Addendum - Report to the Plan Commission

Legistar I.D. #21733
1907-1911 Monroe Street
Demolition and Rezoning

Report Prepared By:
Heather Stouder, AICP
Planning Division Staff

A-2.2

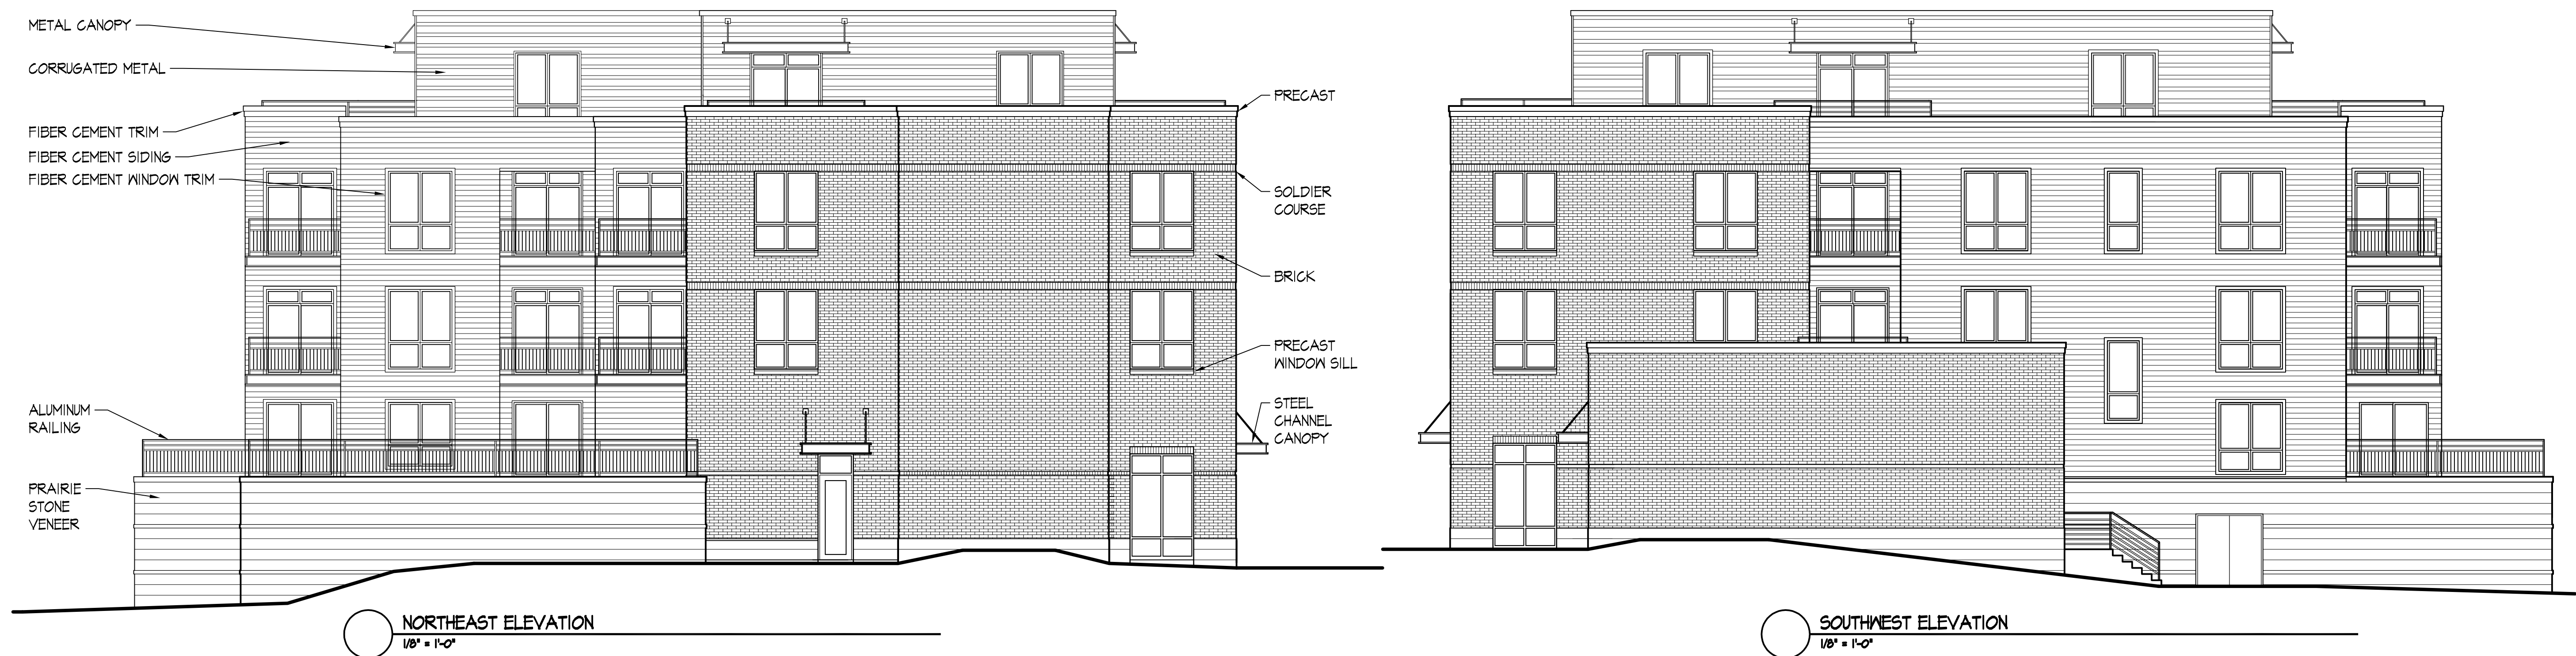
In recent days, some area residents have noted a preference for an early design version of this project as it was shown to the neighborhood prior to a formal submittal (see "A" below). They have discouraged the evolution of the design to the slightly more contemporary design (see "B" below), which was encouraged by the Urban Design Commission at a March 2 informational presentation and is preferred by the applicant. Following this addendum, four-sided elevations of both options with the building materials specified are included for Plan Commission Review.

Members noted that one prevailing component of successful retail establishments along the street is the glass-walled storefront windows on the ground floor, which is reflected to a greater extent in Design "B". The storefront window elements act to enliven first floor retail activity, and the greater transparency provides more appeal to the commercial use and contributes to the vibrancy of the streetscape.

Design "A" and Design "B" are the same with regard to bulk, mass, and land use, and differ only based on the "skin" of the building. Planning Division staff believes that either version of the design is consistent with the Monroe Street Commercial Corridor Plan, and would meet the high standards for Planned Unit Developments. That said, staff agrees with a point made by UDC members regarding the superiority of the solid glass storefront in "B". Further, staff believes that Design "B" includes fresh architectural details, including the composite panel accents and corrugated metal top, while maintaining a durable masonry facade that would fit in well along this stretch of Monroe Street.

After a long discussion, Rummel (second by Lufler) moved to approve Design "A", stating a concern that the neighborhood may not have had ample opportunity to see the revised elevations that were previously encouraged by the UDC. This motion failed 3-4, with the Chair breaking a tie. A second motion was made by O'Kroley (second by Smith) to approve Design "B". This motion carried 4-2. The UDC granted **final approval** for Design "B", recommending it for approval by the Plan Commission.

Staff further recommends that the Plan Commission find that the standards for demolition approval, rezoning, and Planned Unit Developments can be met, and forward this request to the June 7 meeting of the Common Council with a recommendation for **approval** and a clear indication of their design recommendation.
